City of Sonoma
City Council
Agenda Item Summary

City Council Agenda Item: 6A

Agenda Item Title

Discussion, consideration and possible action on an appeal of the Design Review and Historic Preservation Commission's decision to approve the application of Studio 101 Designs for design review of two commercial buildings and a trash enclosure at 19366 and 19370 Sonoma Highway.

1 **LANDSCAPE PLAN**
SCALE: 1/8"=1'-0"

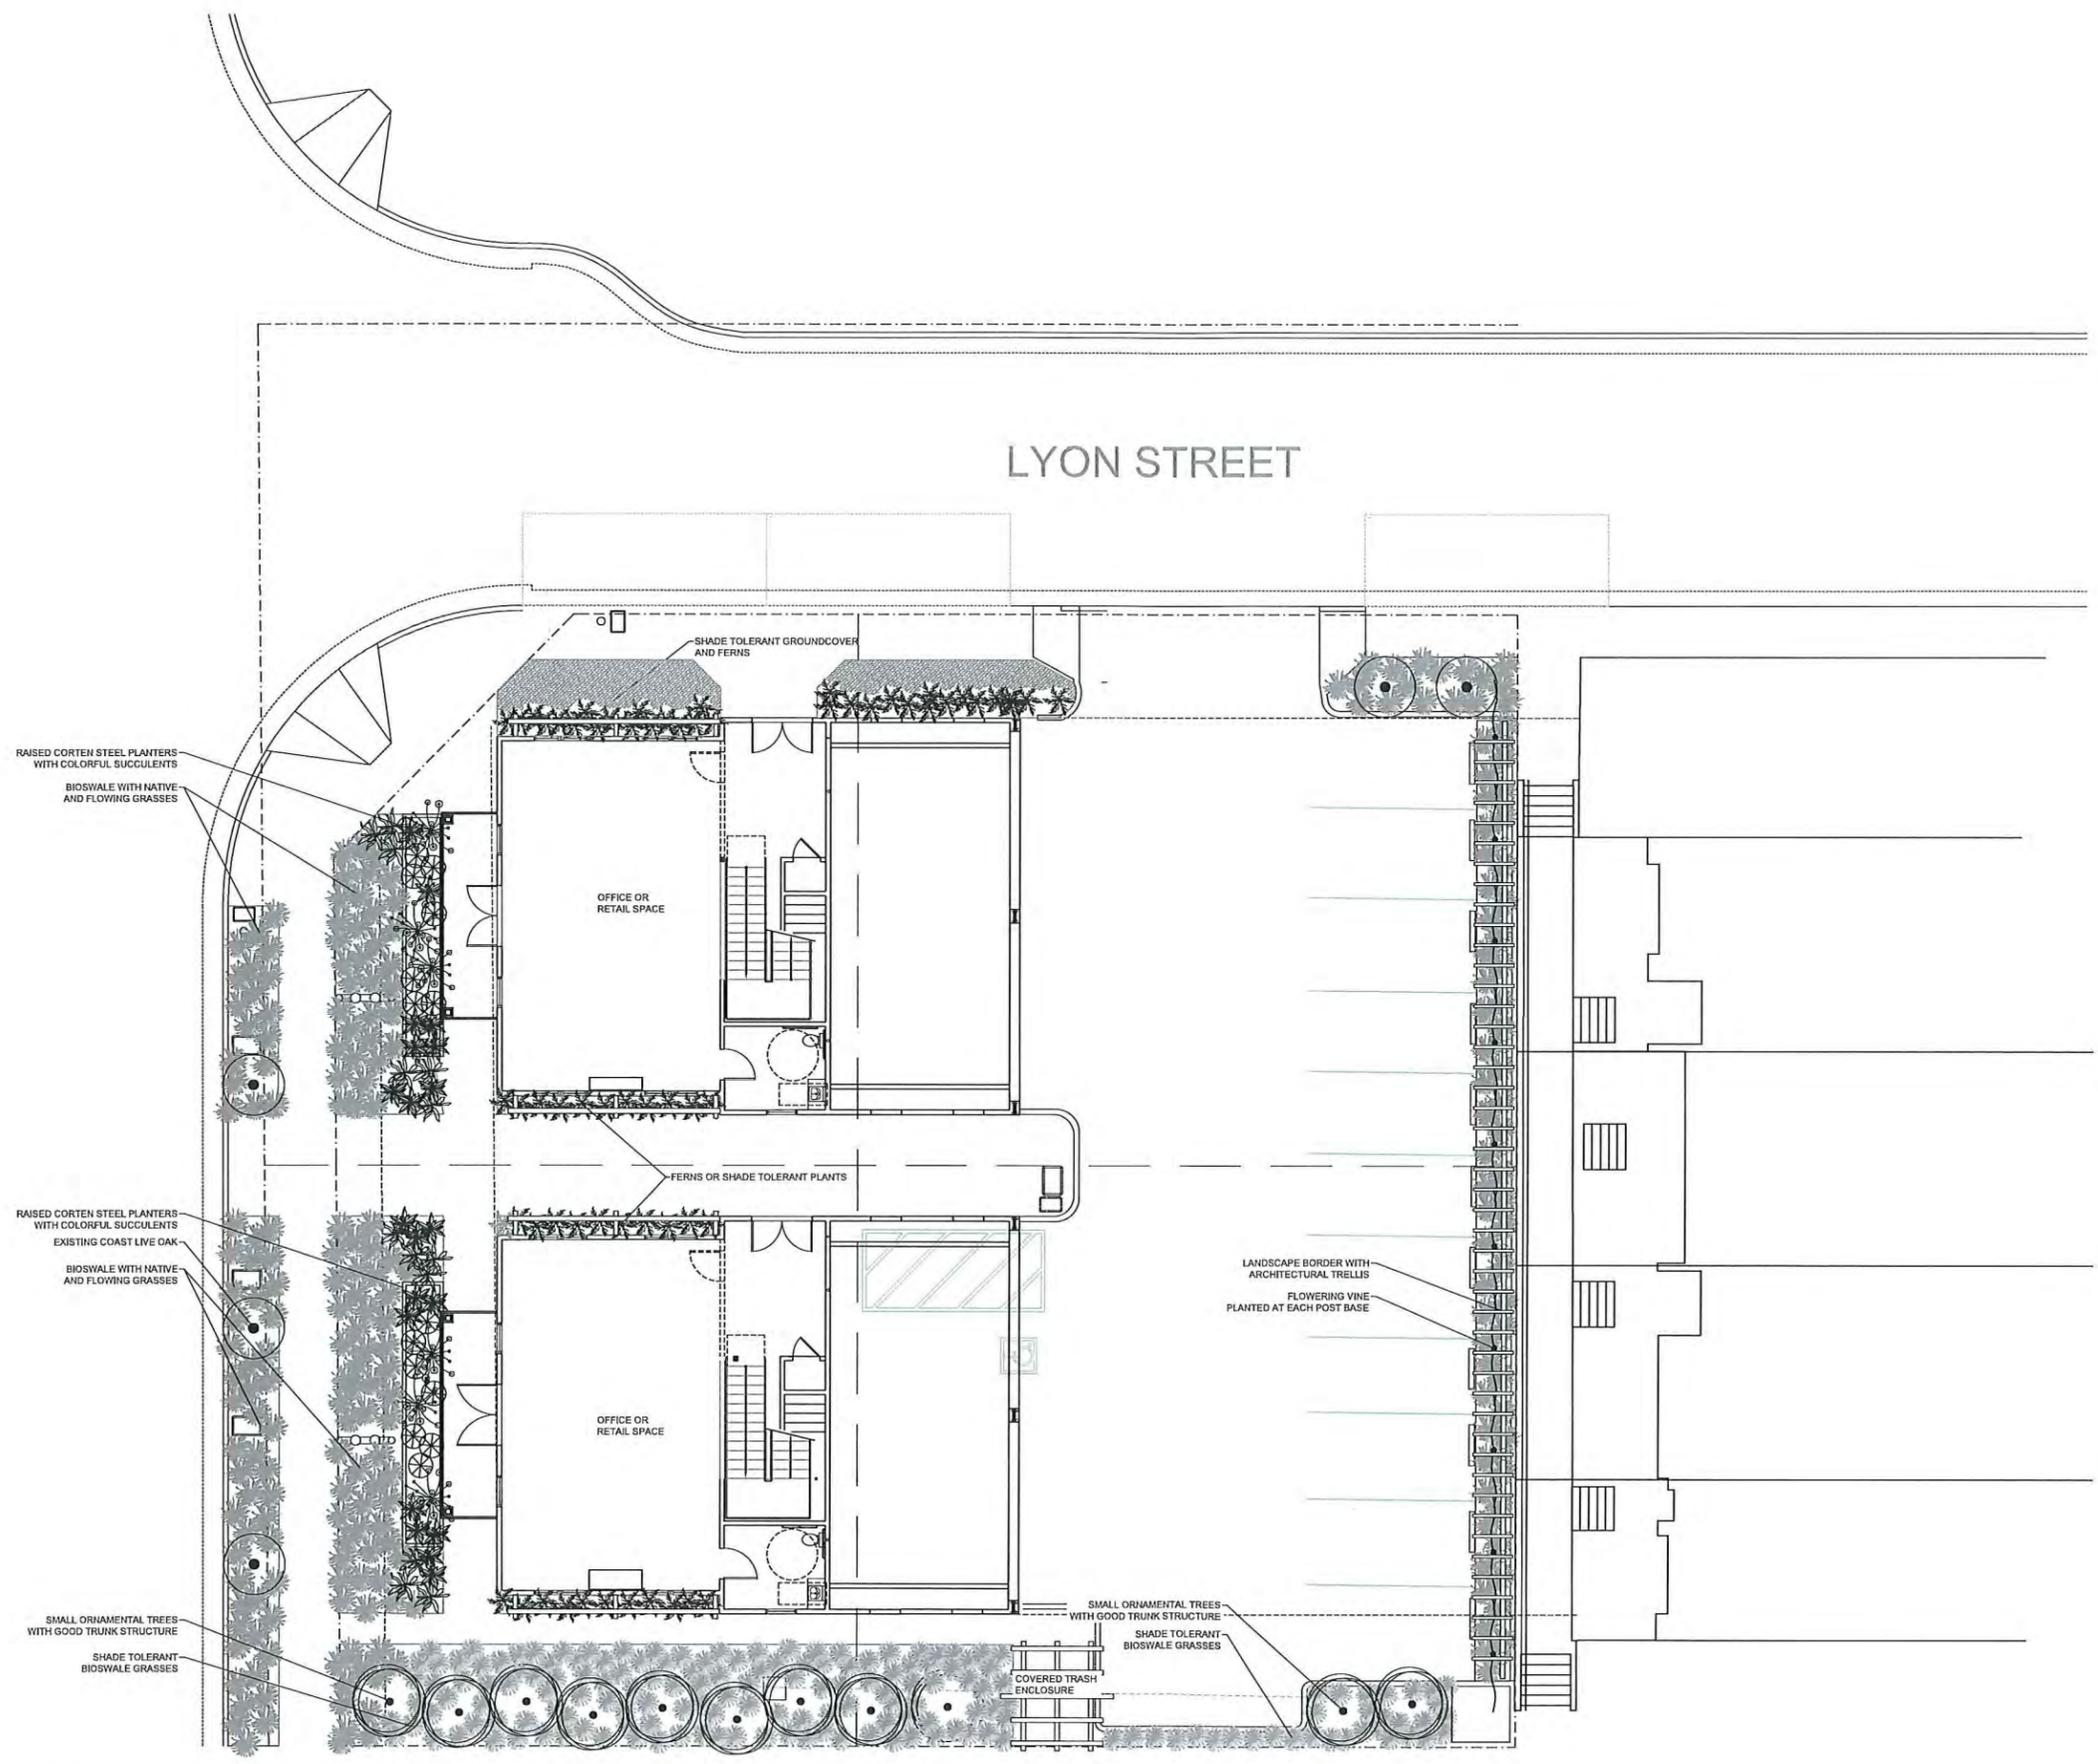
The trellises are a nice start, but to provide adequate screening and buffering, a wall and additional trees are required as well. And to accomplish this buffer yard contemplated by the code, the landscaped area should be four and one-half to five feet wide.

Section 19.48.090(F) requires that between non-residential and residential uses there shall be a buffer yard with a minimum six-foot wall of wood or masonry. There are to be trees every 30 feet at a minimum. The wall must provide an opaque screen and shall be architecturally treated on both sides (Section 19.40.100(a)(1)(2).) This code section does not specify a width. However, a closely related provision offers guidance. Section 19.48.090(E) mandates a five-foot wide buffer between a parking lot and an adjoining public street. Given that the code requires “at a minimum, adequate screening and buffering,” the five-foot width provides a useful standard for the buffer yard.

We envision the buffer yard to include the six- to seven-foot wall required by the code with trees set, at a minimum, every 30 feet on the town home side of the wall, and shrubs and flowers in the spaces between the trees. As to the initial planting, the code requires

The question may arise as to how to harvest the necessary five feet for the buffer yard. We believe one answer is to move the commercial buildings four and one-half feet forward toward Sonoma Highway; that is, move them from the currently designed 22.5-foot setback to a setback line of 18 feet. At the DRC meeting, two of the commissioners suggested this themselves. Commissioner Johnson expressed a concern for an adequate buffer zone and suggested pushing the buildings forward. Commissioner Essert advocated moving the buildings toward Highway 12 to provide more room for the buffer. Mr. Essert also discussed the option of underground parking to make room for the buffer. He explored this concept with your architect who ultimately conceded that underground parking was feasible. Furthermore, an 18-foot setback is within the contemplation of the City. In Mr. Goodison's staff report to the Planning Commission regarding your 2015 application, he stated that an 18-foot setback could apply to the buildings then envisioned as part commercial, part residential. An 18-foot setback is a win-win for you as well as the neighborhood. You can maintain the current square footage of your commercial spaces as well as supplying the parking necessary to serve them. The residents will enjoy a five-foot wide, well-landscaped, opaque buffer with beautiful trees and shrubs, creating privacy. Commercial and residential uses can co-exist harmoniously.

- *Landscape Buffer:* The appellants state that a landscape buffer should be provided between the commercial parking lot and the adjoining townhomes on the east. As noted above, the revised landscaping plan reviewed by the DRHPC at the August 16, 2016 meeting was denied. Because the landscaping plan was denied, it is outside of the scope of the DRHPC's approval of the commercial building design, which is the decision that has been appealed. In addition, due to the denial, the applicant is already required to develop and submit a new landscaping plan. The applicant has consulted with interested neighbors on a revised plan intended to resolve the screening issue, which is scheduled for review by the DRHPC on October 18, 2016. While there continues to be disagreement as to whether the latest solution proposed by the applicant is adequate, the City Council cannot take action on that matter until after the DRHPC review process has been completed and then only if an appeal of the final decision is made.

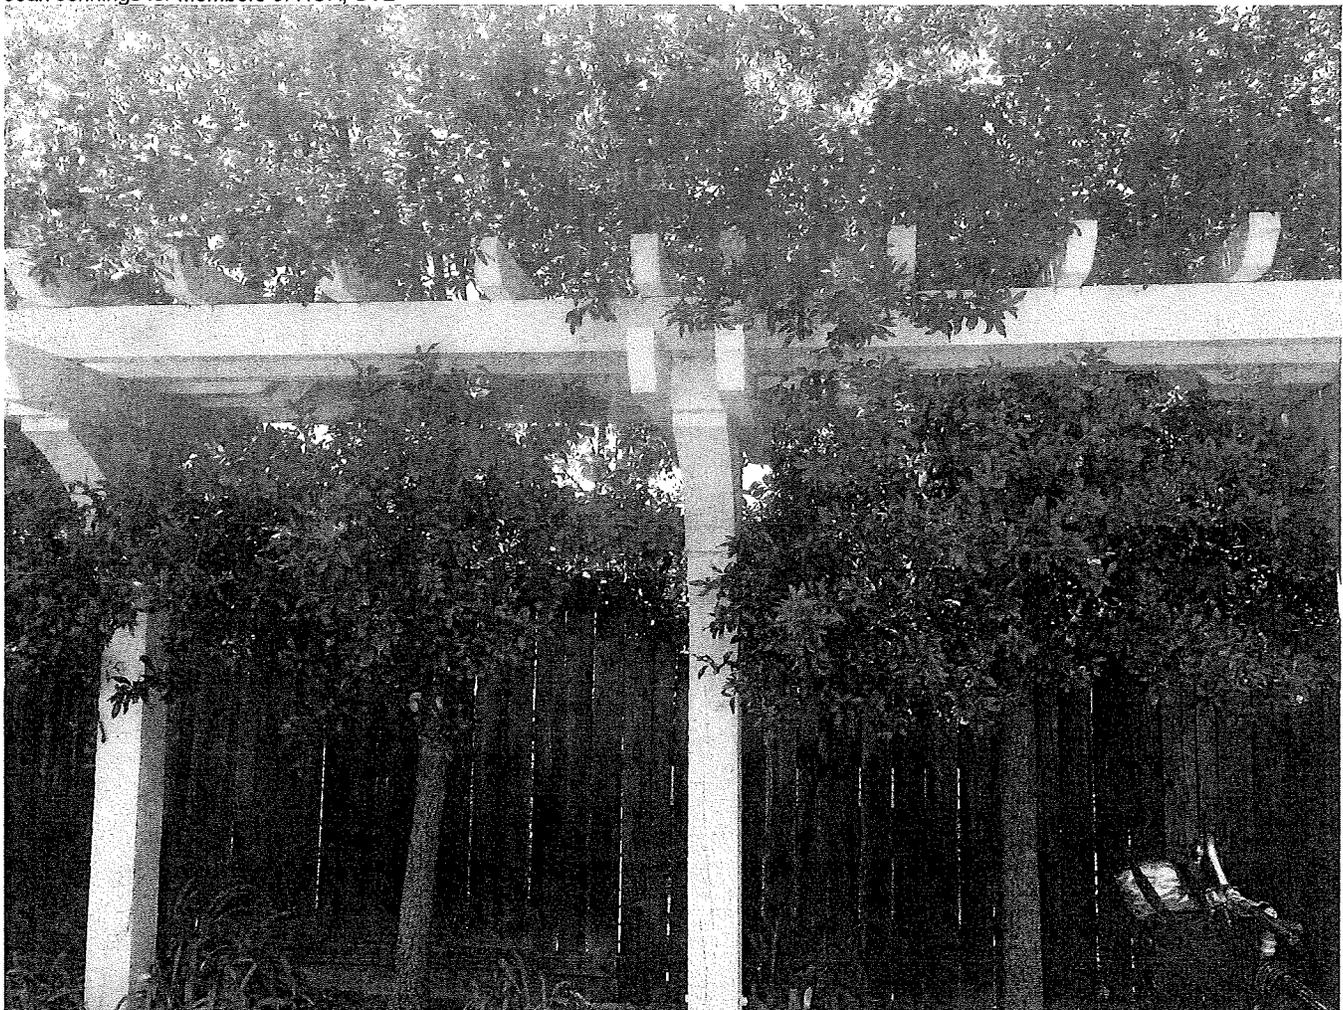
Here are some photos of trees and trellises from the Derringer project on First Street West. We showed these to you on June 30 at our meeting, but they are worth looking at again.

The trellises are beautiful and well made, and the trees project up nicely through the interstices. We think something like this would accomplish the desired end.

If we did something like this, then a vine would be superfluous. We would also need some kind of box hedge, shrub, or other hedge to cover the cement wall in the back. It would be important to get trees that grow to the right height. Because redbuds are colorful and a good height, we don't think they should be ruled out. There are all kinds of redbud trees, big and small.

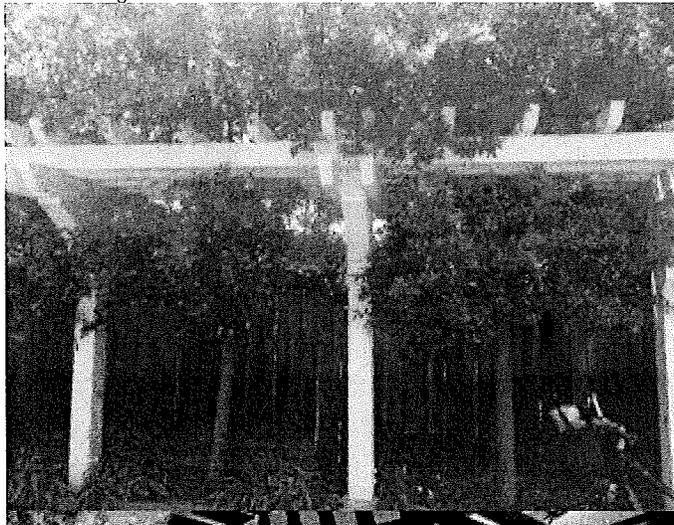
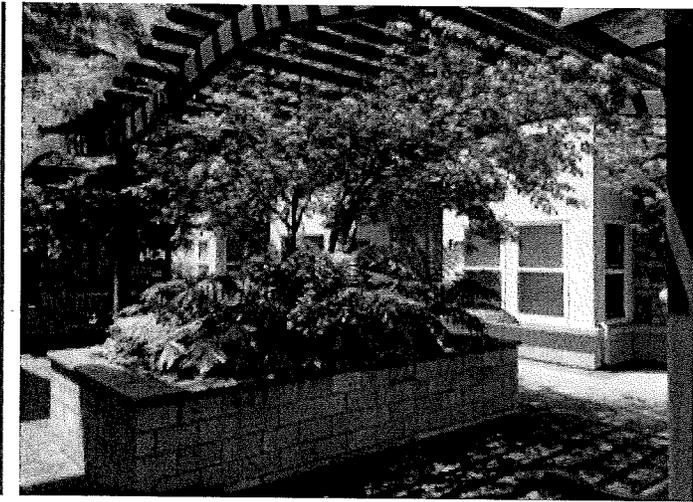
Here are some photos of trees and trellises from the Derringer project on First Street West. We showed these to you on June 30 at our meeting, but they are worth looking at again.

The trellises are beautiful and well made, and the trees project up nicely through the interstices. We think something like this would accomplish the desired end.

If we did something like this, then a vine would be superfluous. We would also need some kind of box hedge, shrub, or other hedge to cover the cement wall in the back. It would be important to get trees that grow to the right height. Because redbuds are colorful and a good height, we don't think they should be ruled out. There are all kinds of redbud trees, big and small.
